# Technical Announcement

Delta Electronics, Inc. IABG

Product	ASDA-B3	Applicable Model	B3-M	Security Classification	<input checked="" type="checkbox"/> General
			B3-F B3-E B3-L		<input type="checkbox"/> Confidential <input type="checkbox"/> Highly Confidential
Issued by	ASD	Author	Chloe Chen	ECN No.	126A-203049
				Issue No.	ASD20092400
Recipient	Sales Representative (Taiwan), Product Manager (Taiwan), DGC, DEU, DPR, DES, DEK, DEJ, and DIN

Firmware update release for the ASDA-B3 series products.

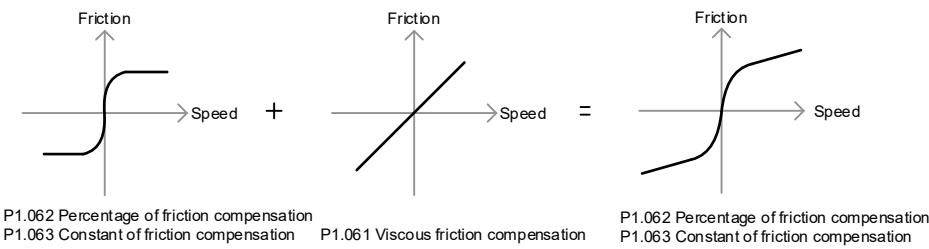
1. Added Heartbeat function in CANopen mode.
2. Added PFQS function in communication mode.
3. Added: in the communication mode, set OD 6060 to 0 to stop the motor.
4. Added: in the communication mode, all alarms are automatically cleared when the communication is initializing.
5. Added: in the EtherCAT communication mode, use the communication to access hidden parameters.
6. The EtherCAT communication diagnostic system is supported.
7. Added monitoring variables of -169 Regenerative resistor overload (AL086) protection

counter, -202 Degree of motor electrical angle, and -207 Regenerative resistor power consumption.

Code	Variable name / property	Description
-169	Regenerative resistor overload (AL086) protection counter	This variable monitors the average power consumed by the regenerative resistor (unit: %) when the capacitor energy of the servo drive is released to the regenerative resistor. When the value reaches 100%, AL086 is triggered.
-202	Degree of motor electrical angle	The current electrical angle degree x 4.
-207	Regenerative resistor power consumption	This variable monitors the power consumed by the regenerative resistor (unit: %) at the moment when the capacitor energy of the servo drive is released to the regenerative resistor.
